GeoShield Verification Report

PROJECT REFERENCE: GEO103300

PROJECT: Leeds Road, Mirfield

AREA SURVEYED: Plots 11 & 12 (Perimeters and Party Wall)

VERIFICATION ITEM THREE

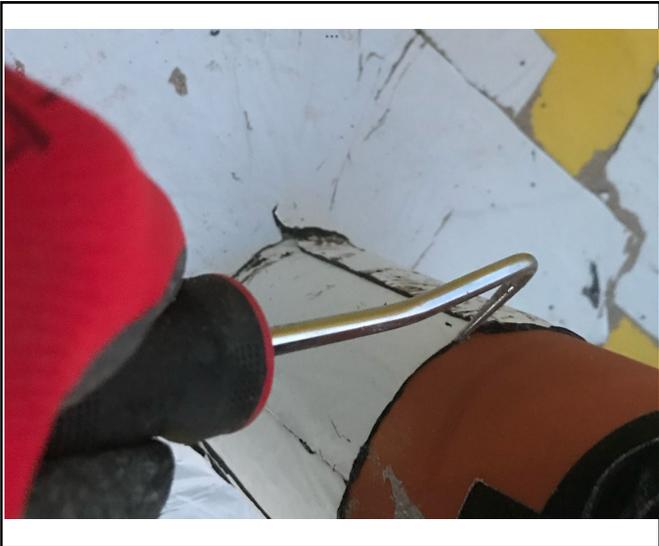
The overview image shows the typical perimeter installation of the Rhinoplast

Total Gas Barrier where the various lap joints proved to be correctly sealed. The

internal/external corners and reveals were all successfully sealed using strips

of Gas Resistant Detail Strip.

ADDITIONAL PHOTOGRAPHS

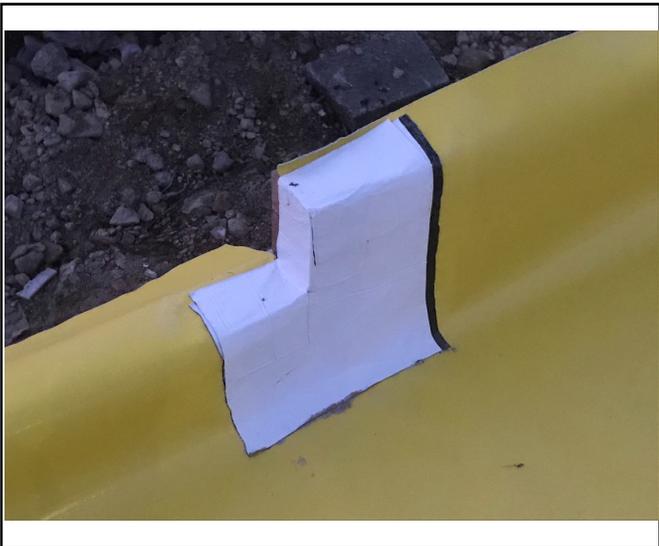
View of typical pipe penetration sealed

with Gas Resistant Detail Strip
